BLACK HORSE PIKE REGIONAL SCHOOL DISTRICT
Highland HS 2025 LMC Corridor & Classroom Renovations (GA# 23-73)
Addendum #1– Cover Sheet
January 9, 2025

BLACK HORSE PIKE REGIONAL SCHOOL DISTRICT
Highland HS 2025 LMC Corridor & Classroom Renovations (GA# 23-73)
Addendum #1 - Narrative
January 9, 2025

BLACK HORSE PIKE REGIONAL SCHOOL DISTRICT
Highland HS 2025 LMC Corridor & Classroom Renovations (GA# 23-73)
Addendum #1 – Contractor Questions and Answers

1 EGRESS FLOOR PLAN - BASE BID - CONSTRUCTION PHASE (DURING SCHOOL YEAR) - 4/28/25 THRU 6/20/25
A-0 SCALE: 1/16" = 1'-0"

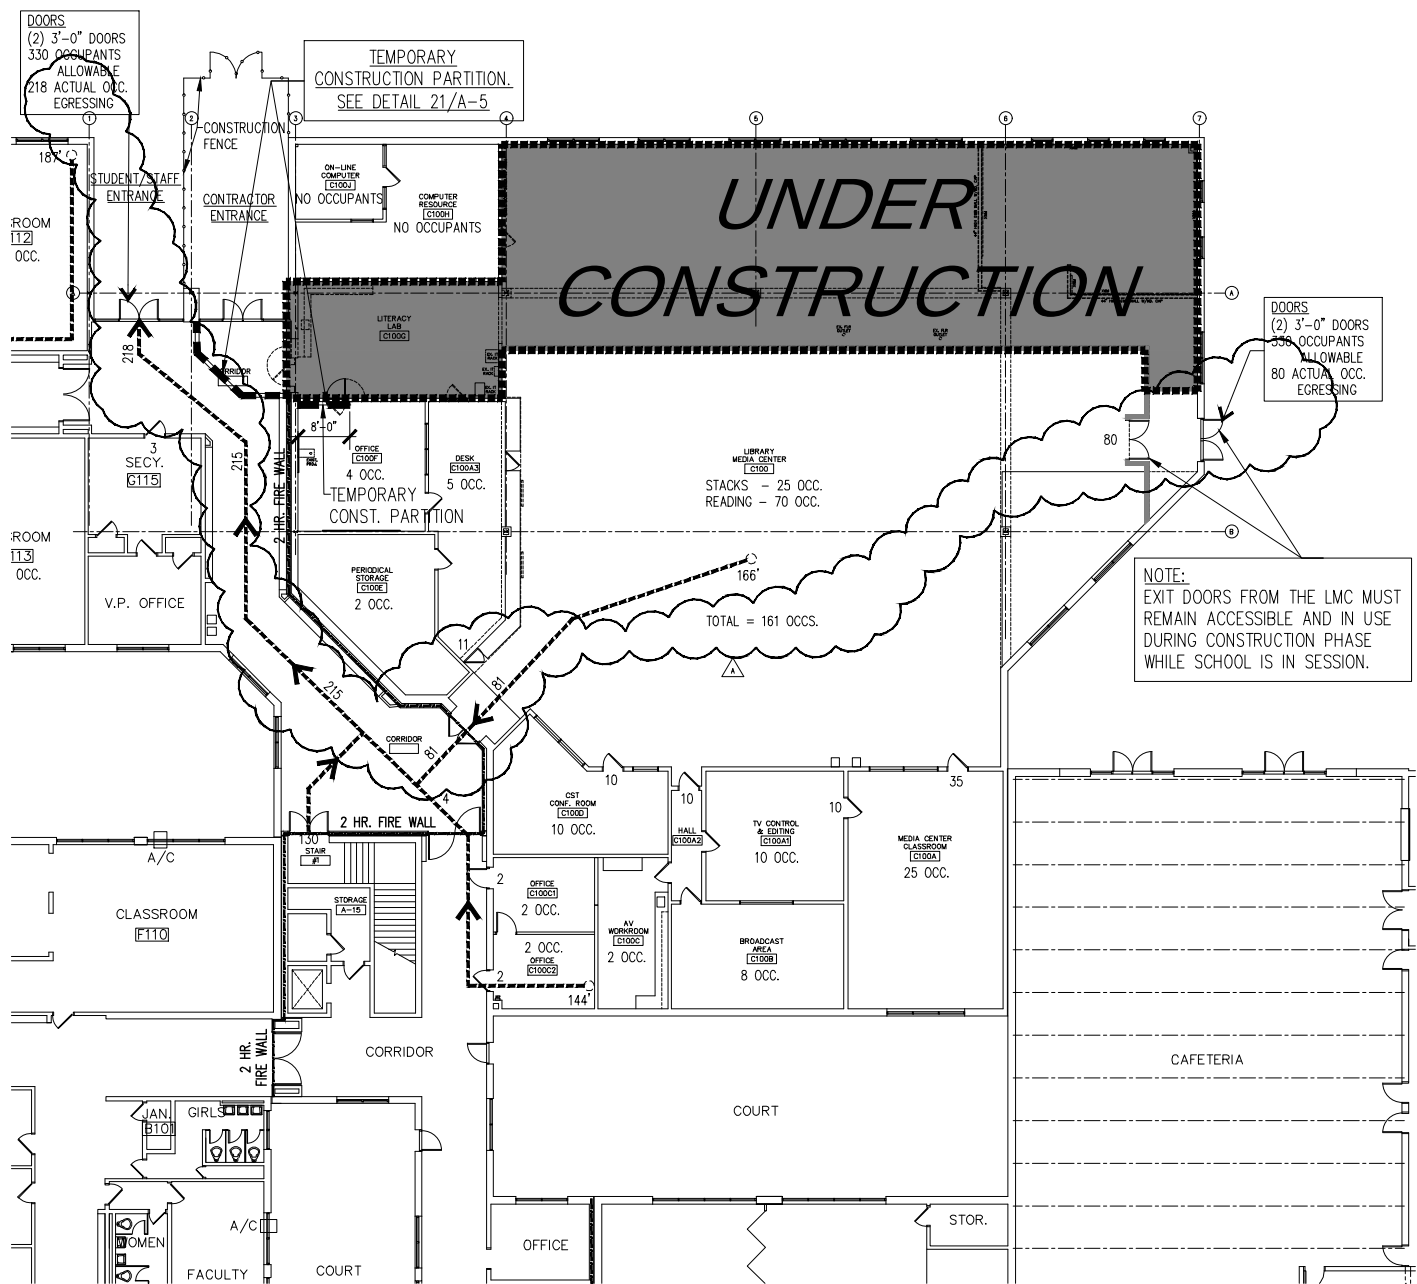
1. On Drawing A-0:
 - a. **REVISE** Drawing as per the **ATTACHED Sketch ADM-1.01 (1 Sketch)**.
 - b. **REVISE** Drawing as per the **ATTACHED Sketch ADM-1.02 (1 Sketch)**.
2. On Drawing A-0.1:
 - a. **REVISE** Drawing as per the **ATTACHED Sketch ADM-1.03 (1 Sketch)**.
 - b. **REVISE** Drawing as per the **ATTACHED Sketch ADM-1.04 (1 Sketch)**.
3. On Drawing A-1: At detail 1/A-1 Existing/Demolition Floor Plan – Base Bid **REVISE** per the following:

M1.1

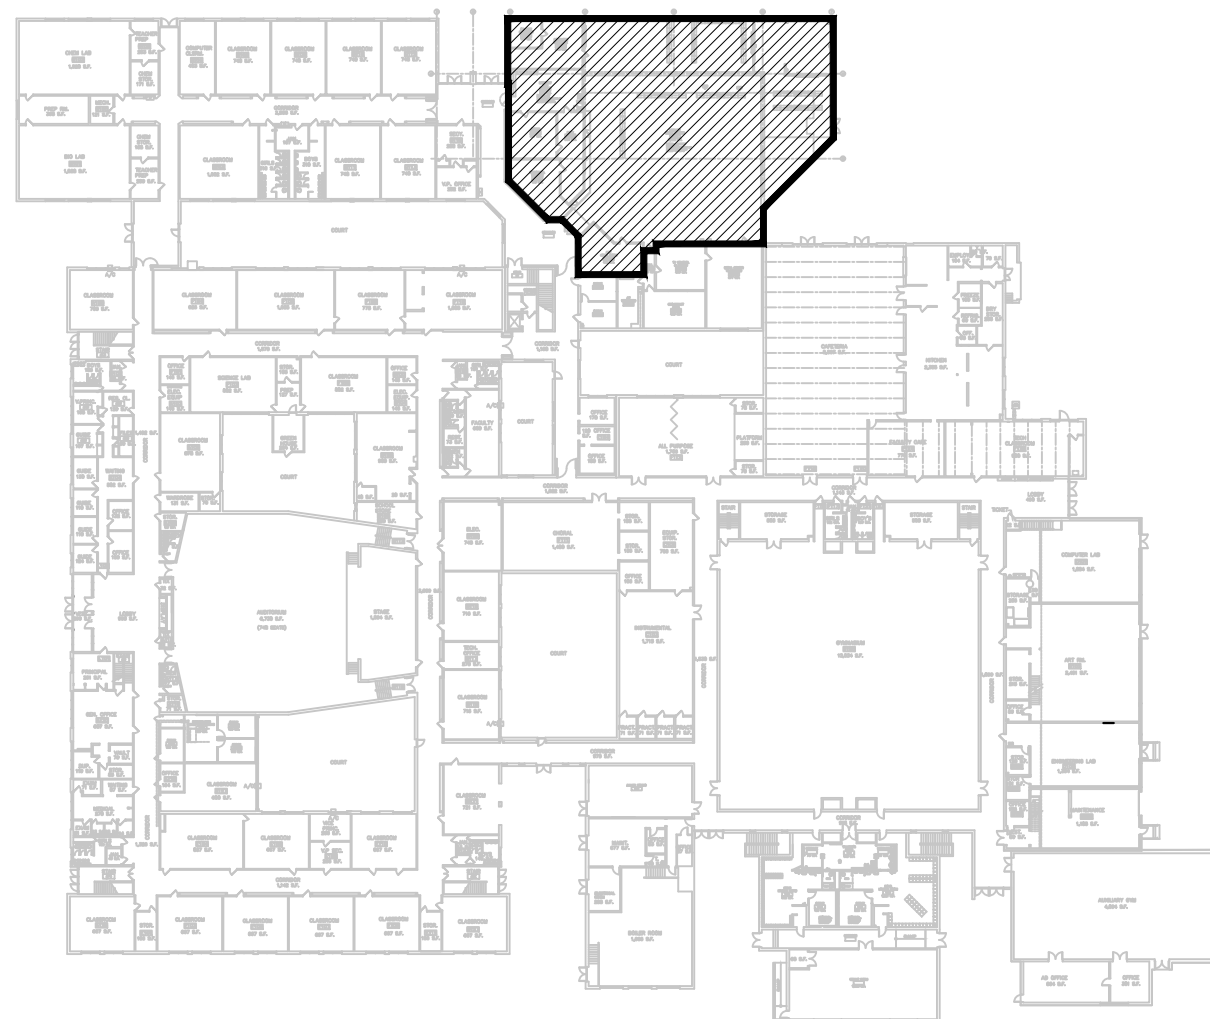
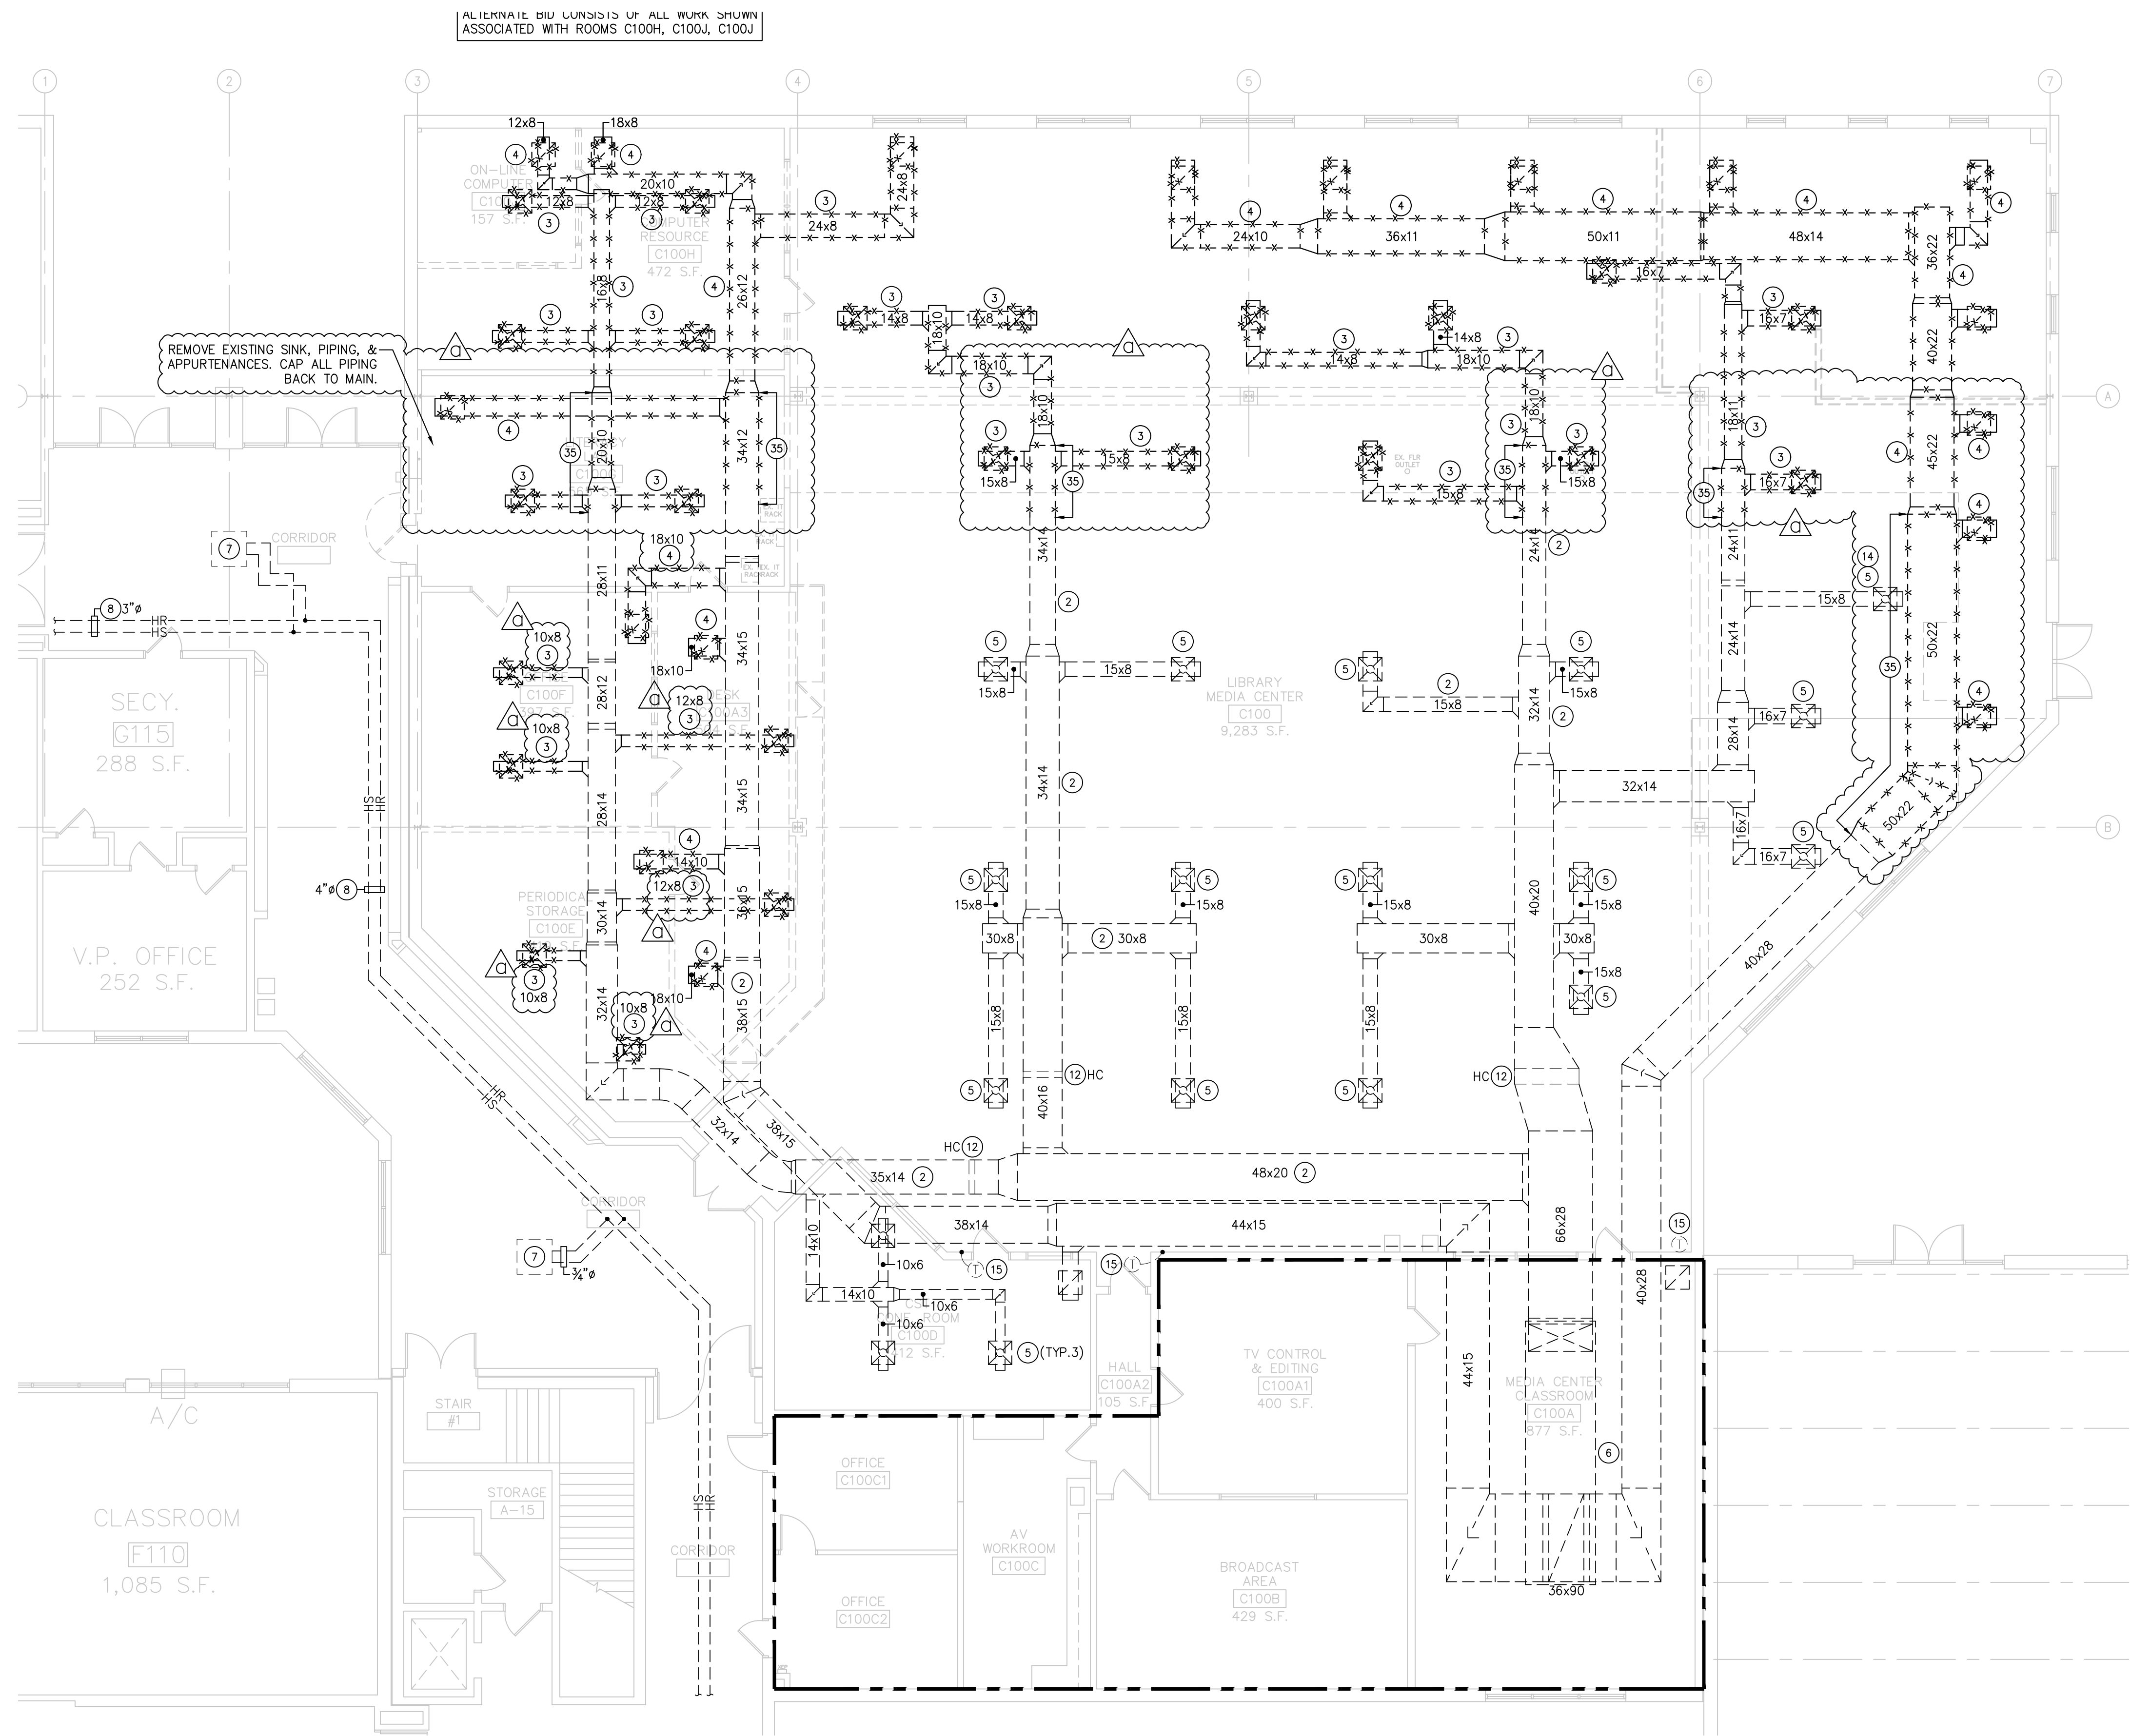
- 2) On M1.1 and M1.1a demo prints there are some missing branch duct sizing needed for patch work (mech sheet note #3). The CFM information is missing for (mech sheet note 5) on several of the GRD's. Needed to rebalance. I also need the existing GRD's CFM for rebalancing as called out in note 5.

- 1) Please confirm there is no Plumbing work required within the project.

Answer: Please see Addendum Narrative for answer.

Answer: The project will have plumbing work. Please see Drawing M1.1 Re-Issued for Addendum #1:01-09-25.
